SUBJECT: Torrance Bridge Maintenance and Beautification- Vegetation and Wooden Guardrailing Removal.

Re: Pacific Electric Railroad Bridge
 Recommendation for complete and sustained removal of vines

Figure 4: Bridge, note addition of wood guardrails and poles supporting overhead catenary and telephone wires (bolts in bridge east and west elevations associated with center poles are still extant), note lack of vegetation on bridge (1940)

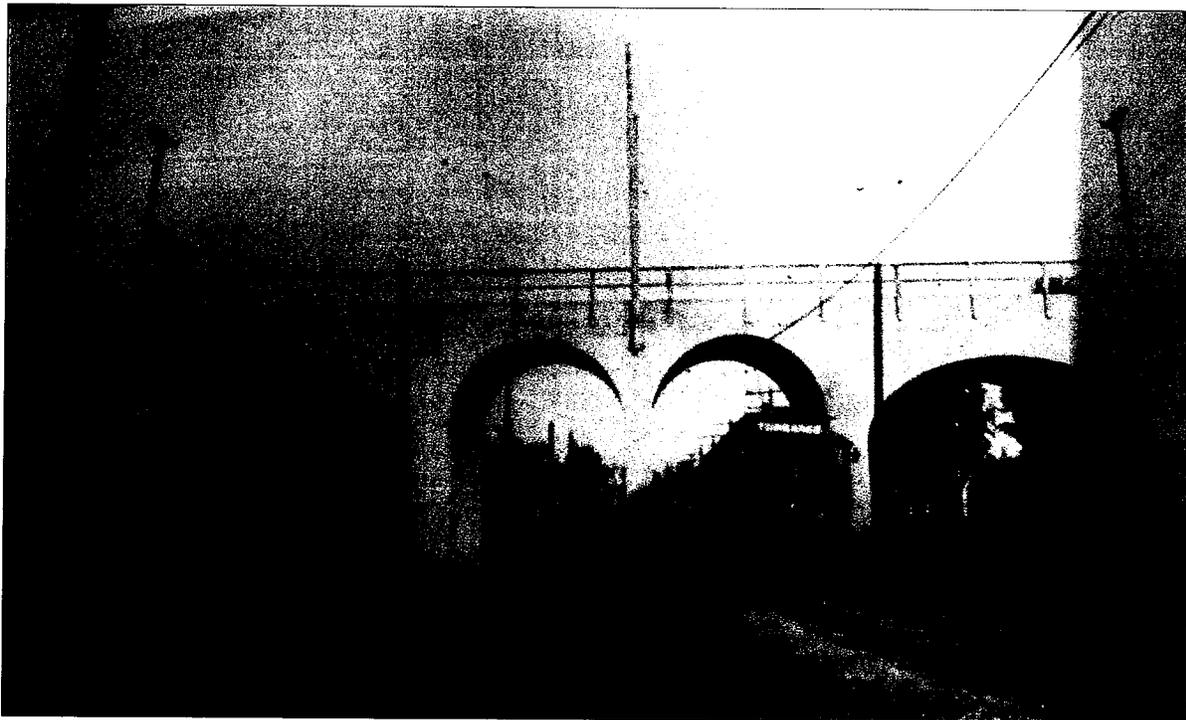
In addition to the vegetation, it was discovered that the wooden guardrails, which were added sometime after 1920, were not part of the original design and are not a contributing feature to the bridge. Additionally, some of the cracking to be repaired on the concrete face of the bridge originates from the bolts that attach the guardrail to the structure. Our thoughts regarding the railings are to remove them permanently, along with the vegetation, to provide a more complete bridge repair and beautification.

1. Per the recommendation of the historical preservationist - Remove all ivy and guardrails from the bridge in order to return the bridge to the condition, as Irving Gill envisioned, without plans to re-establish vines or vegetation on the bridge.
2. Remove all ivy and guardrails from the bridge during this construction phase of repairs, with the intent of reestablishing both the vegetation and guardrails in a future, second design and construction phase. This proposed second phase may include a planned landscaping feature offset from the structure and an ADA compliant guardrailing that is less visible and therefore less intrusive to the historical contributing features of the bridge.
